BOARD ACTION REPORT – APPEALABLE ITEM

Project Name: 32 East Atlantic Avenue
Project Location: 32 East Atlantic Avenue, Old School Square Historic District
Request: Class III Site Plan Modification and Certificate of Appropriateness
Board: Historic Preservation Board
Meeting Date: March 7, 2018

STAFF REPORT

ITEM: 32 East Atlantic Avenue, Old School Square Historic Arts District – Class III Site Plan Modification and Certificate of Appropriateness (2018-004) for alterations to the front façade (North), and installation of a 160 square foot, outdoor, walk-in cooler.

PROPOSED SITE PLAN

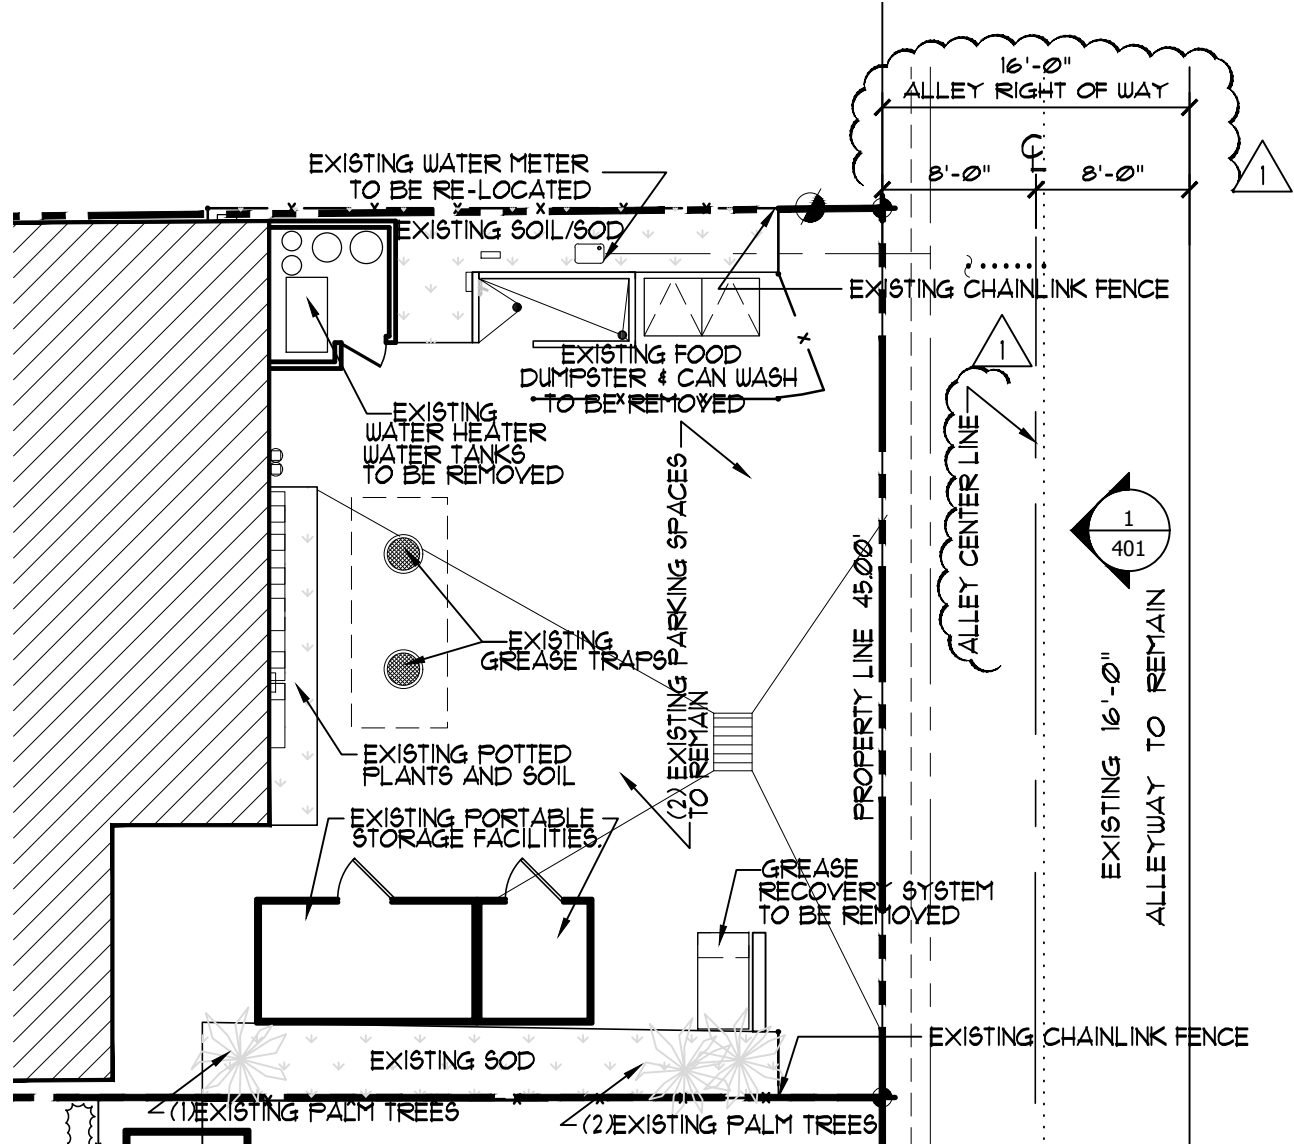
1. In the site data table, on sheet A101, reorganize table to include columns for required, existing, and proposed setback, height, open space, pervious/impervious, etc.
2. In the site data table, on sheet A101, revise the land use designation to OMU (Other Mixed Use).
3. Provide height dimension of the screening of mechanical equipment on top of walk-in cooler on elevation drawings.
4. Submit a revised NOA for the Nana Wall System to correlate with the elevation drawings.

1. In the site data table, on sheet A101, reorganize table to include columns for required, existing, and proposed setback, height, open space, pervious/impervious, etc.
2. In the site data table, on sheet A101, revise the land use designation to OMU (Other Mixed Use).
3. Provide height dimension of the screening of mechanical equipment on top of walk-in cooler on elevation drawings.
4. Submit a revised NOA for the Nana Wall System to correlate with the elevation drawings.

1 NORTH ELEVATION
SCALE: 1/4" = 1'-0"

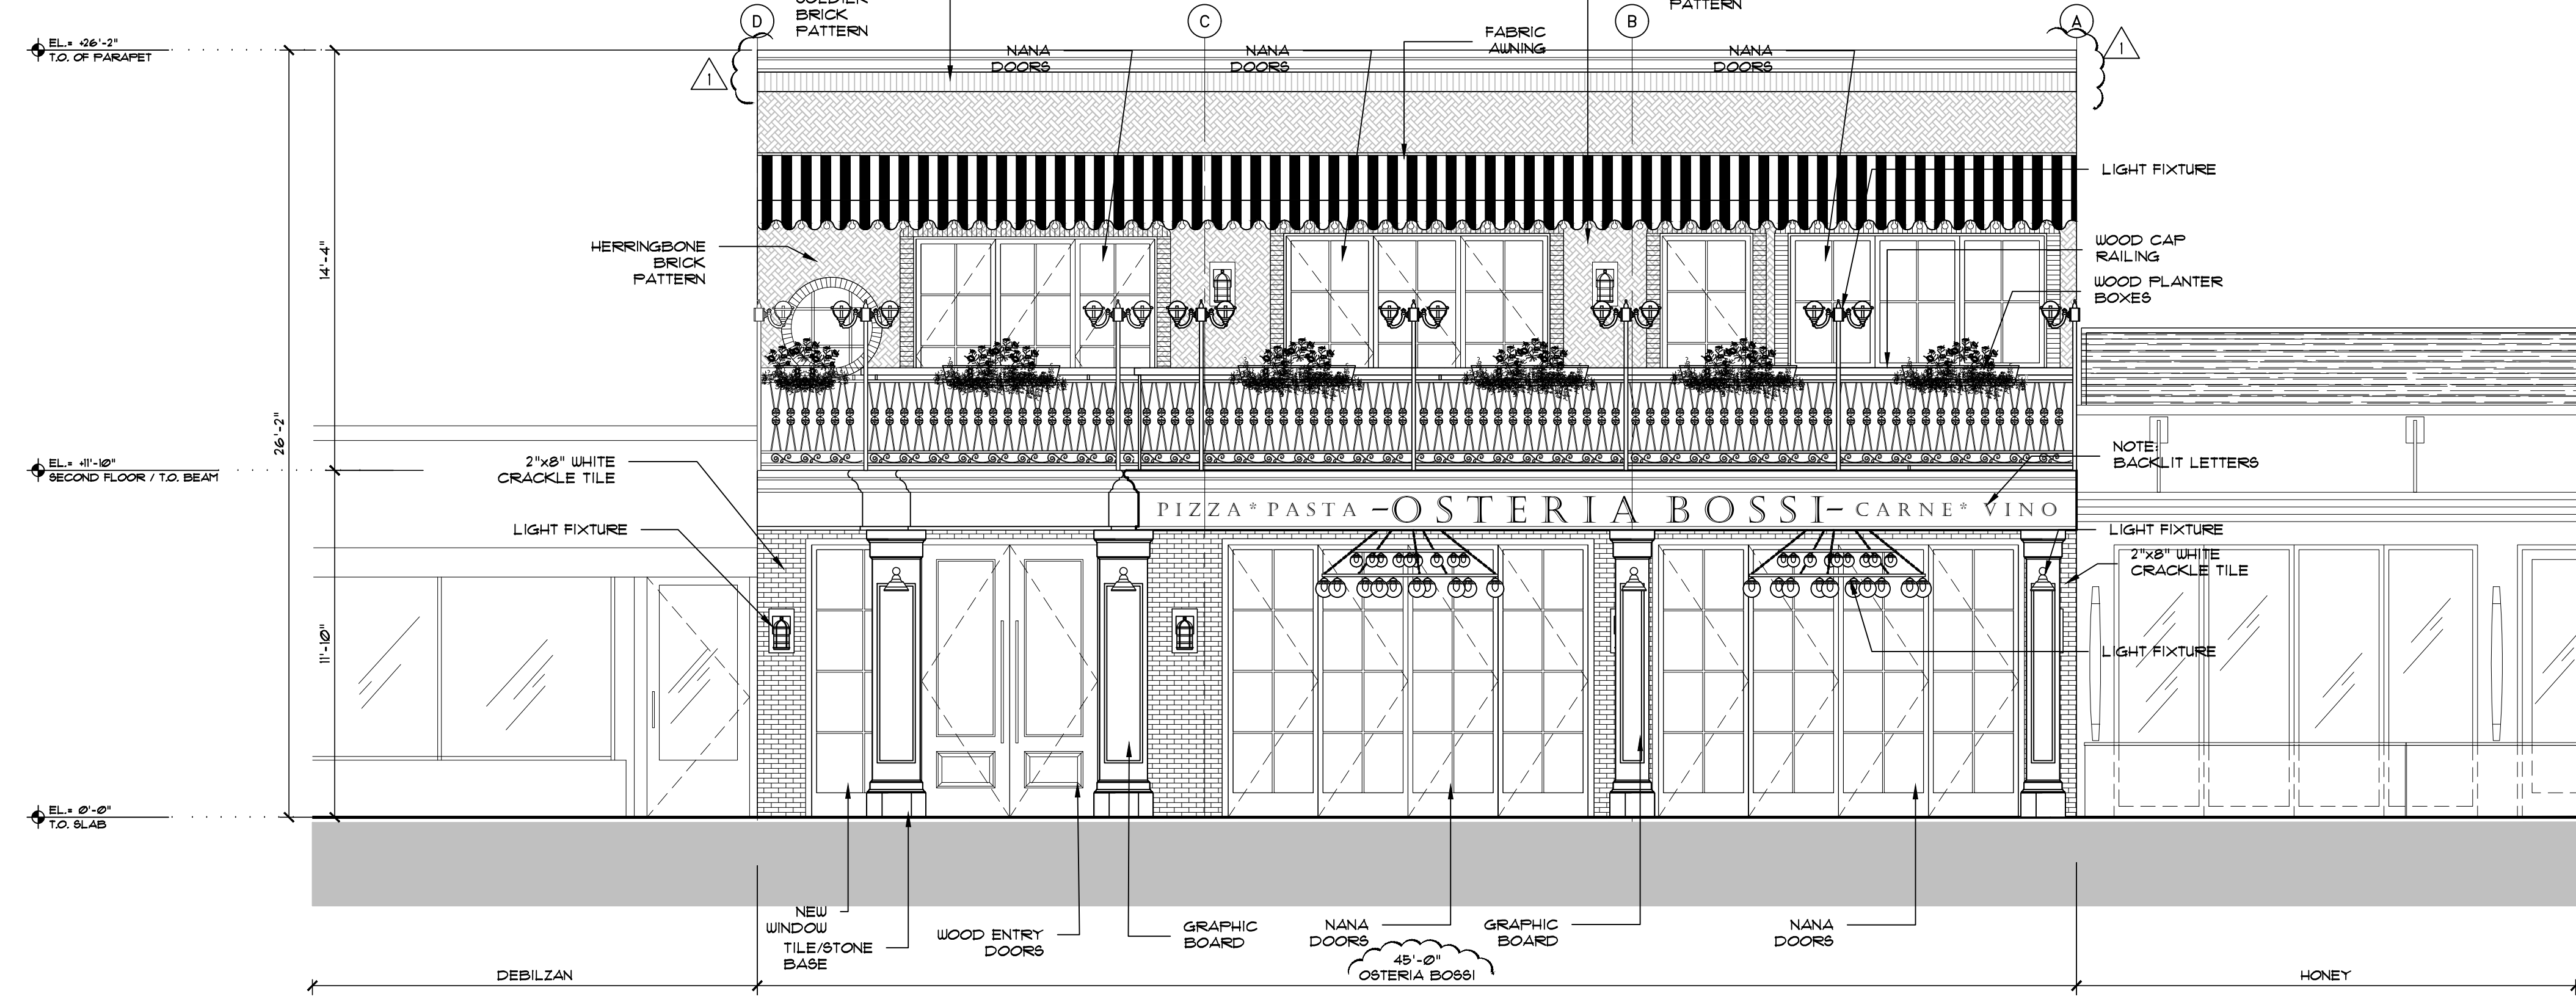
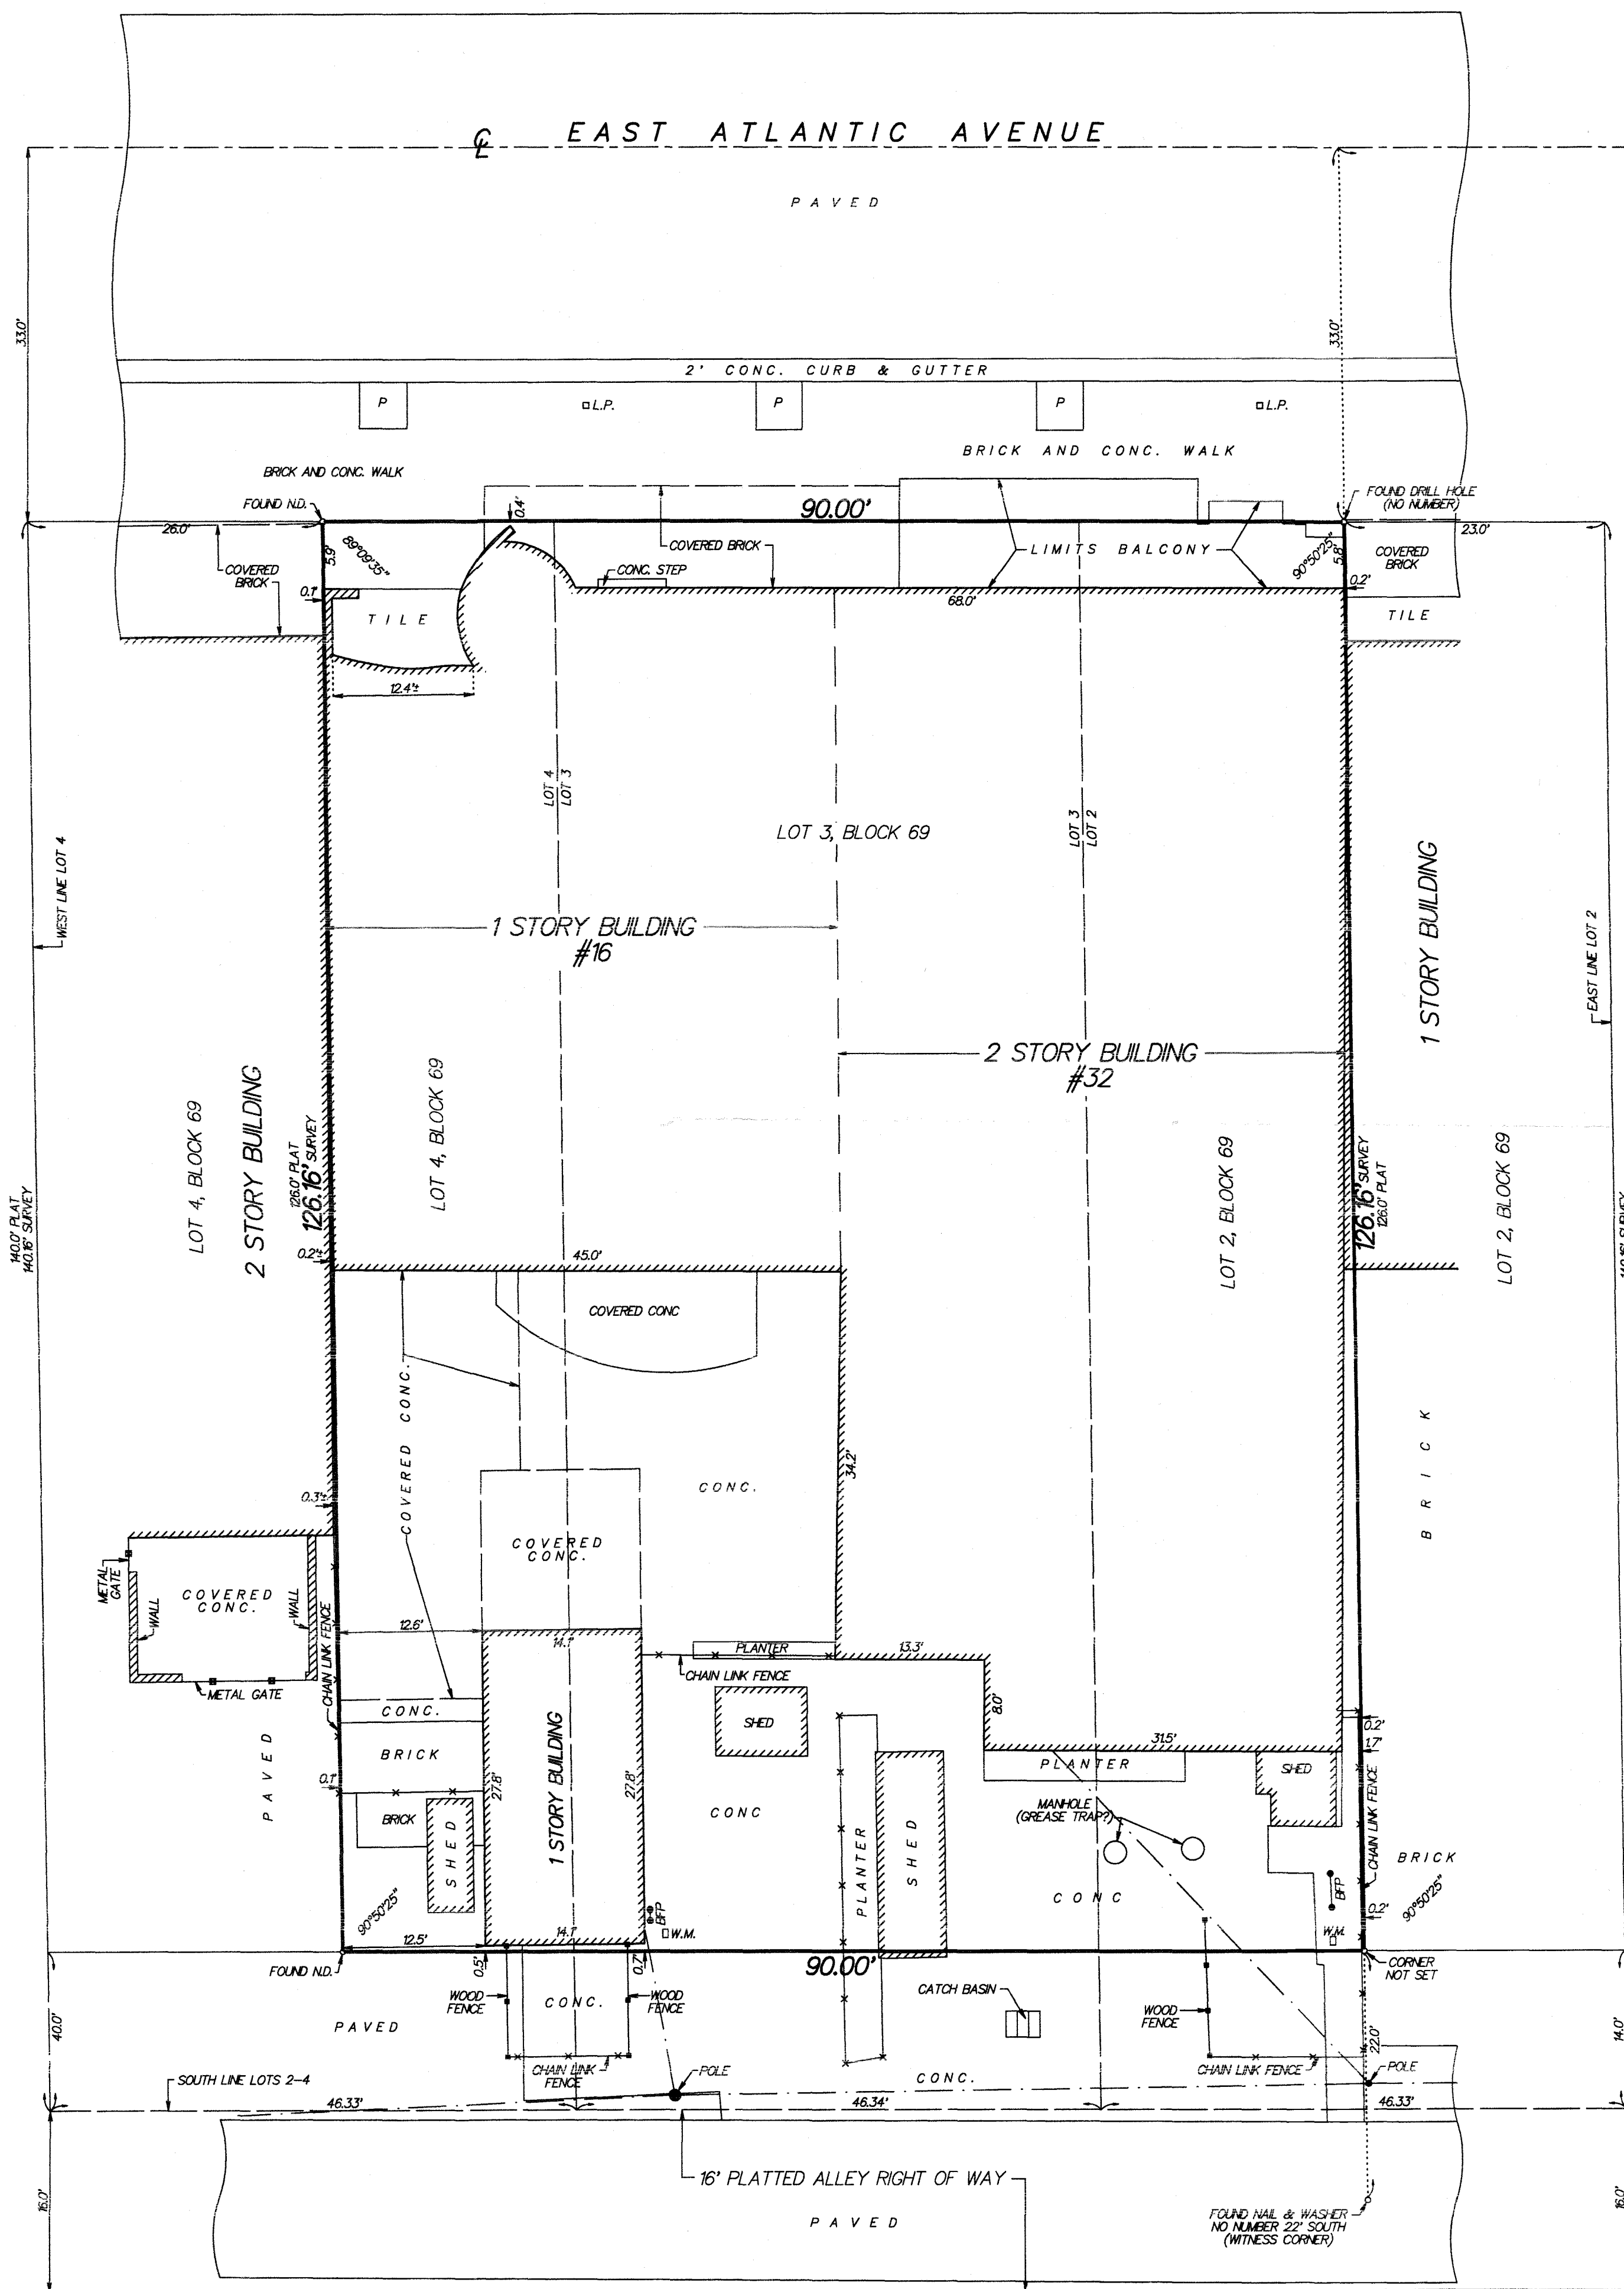
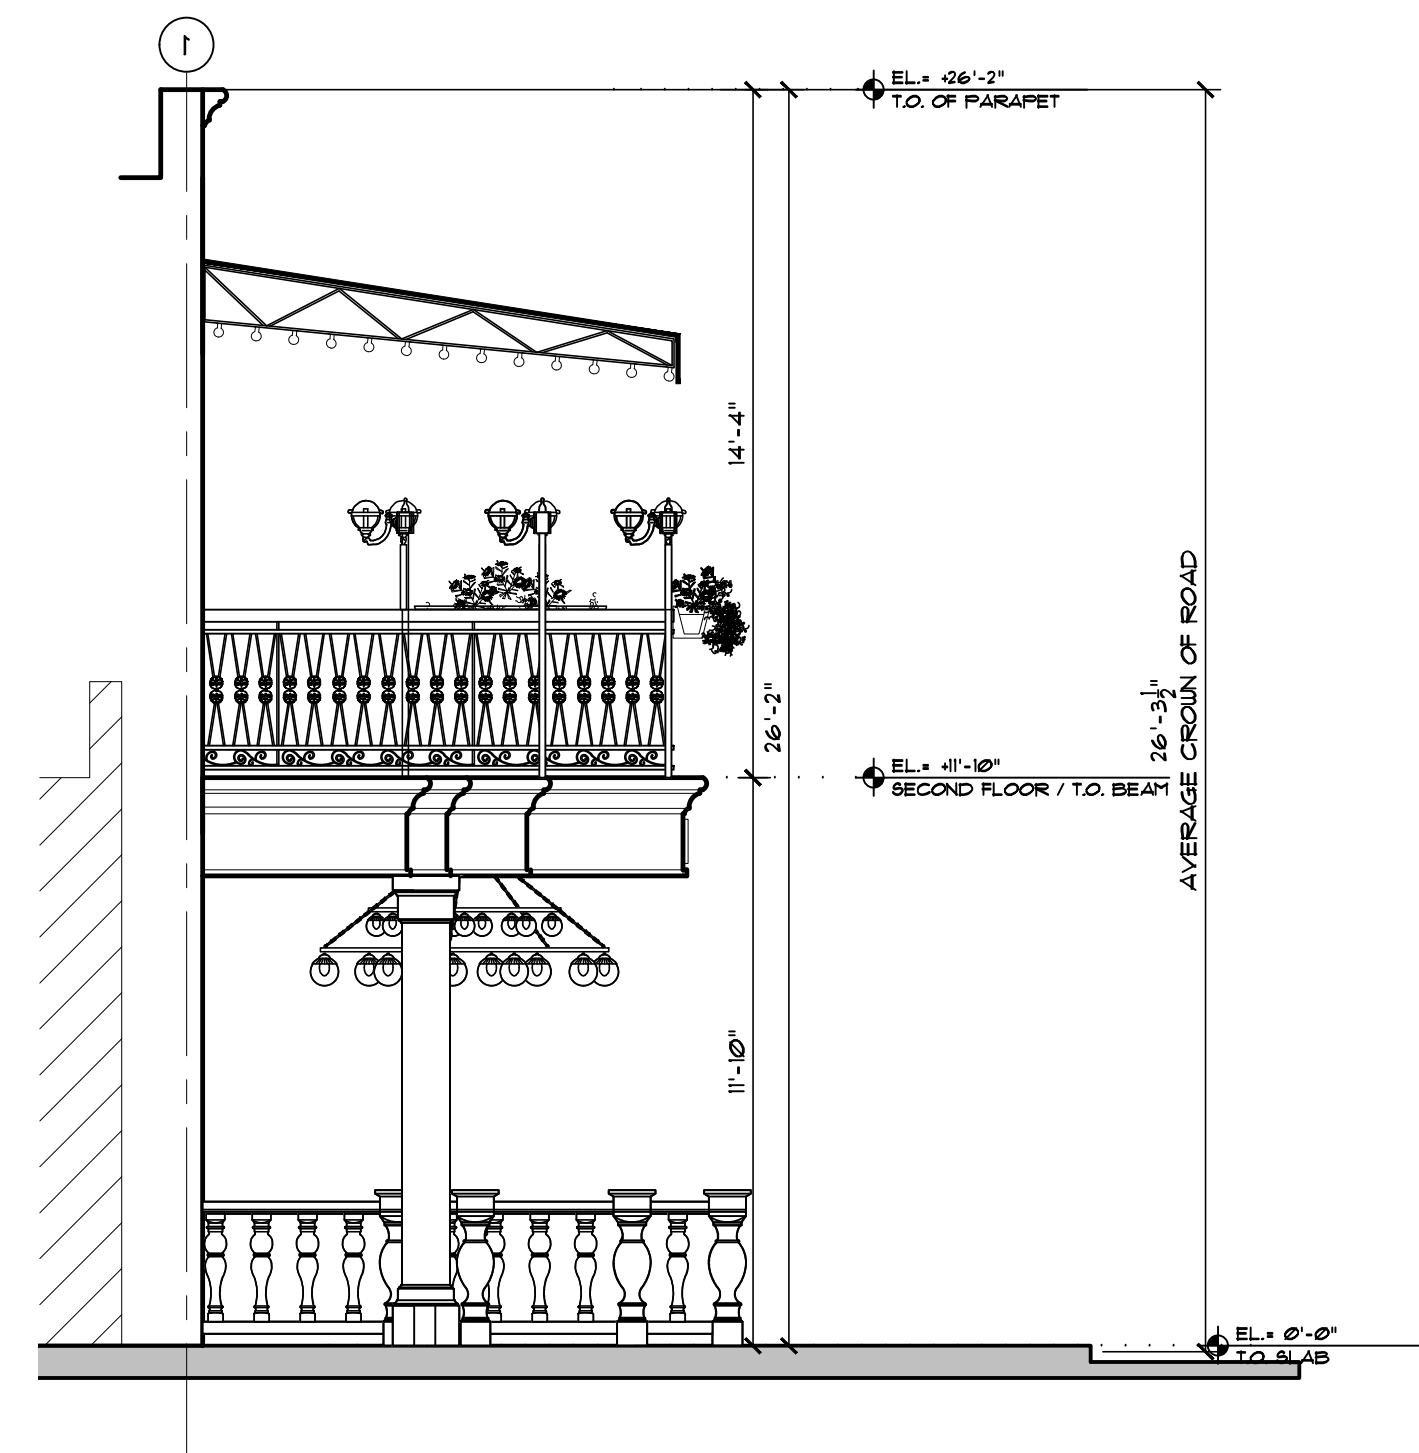
The alterations to the front façade include new nana doors (bi-fold glass wall door systems), wood entry door with glass panels and sidelights, new exterior light fixtures, white cracked tile on the first floor, herringbone brick pattern on the second floor, wood planter boxes along the second floor railing, architectural crown feature at the top of building with soldier brick pattern below, awning, and railing. The exterior color scheme will be changed to Benjamin Moore "Black Ink" moldings, Benjamin Moore "Incense Stick" railing, and Benjamin Moore "Avon green" planter boxes. The spaces that characterize the property are being preserved by maintaining outdoor seating on the

The proposed alterations to the front façade (North) and installation of a 160 square foot, outdoor, walk-in cooler are appropriate and compatible with the Old School Square Historic Arts District (OSSHAD). The alterations to the front façade will increase the height of the building from 24'-4" to 26'-2", these changes will not substantially alter the existing proportion and will maintain a height that is visually compatibility to other buildings in the historic district. The new windows and doors on

the front façade will modify the existing proportion of openings. On the first floor, nana doors (bi-fold glass wall door systems) are being proposed which require larger openings than the existing windows and doors. A wood entry door with glass panels and sidelights on the left side of the door are also being proposed. On the second floor, nana doors are proposed in a different configuration than existing windows and doors. In addition, a new round window is used on the left side of the second floor. These changes are visually compatible to other restaurants on East Atlantic Avenue that maximize visibility with large windows and glass panel doors. The alterations to the front façade include white cracked tile on the first floor, herringbone brick pattern of the second floor, wood planter boxes along the second floor railing, architectural crown feature at the top of building with soldier brick pattern below, exterior light fixtures, awning, and railing. The paint pattern will include Benjamin Moore "Black Ink" moldings, Benjamin Moore "Incense Stick" railing, and Benjamin Moore "Avon green" planter boxes. The relationship of the materials, texture, and color contribute to the "Old Delray Beach" feeling and atmosphere of the Old School Square Historic Arts District (OSSHAD). The proposal creates a cohesive design by introducing elements from only one architectural style.
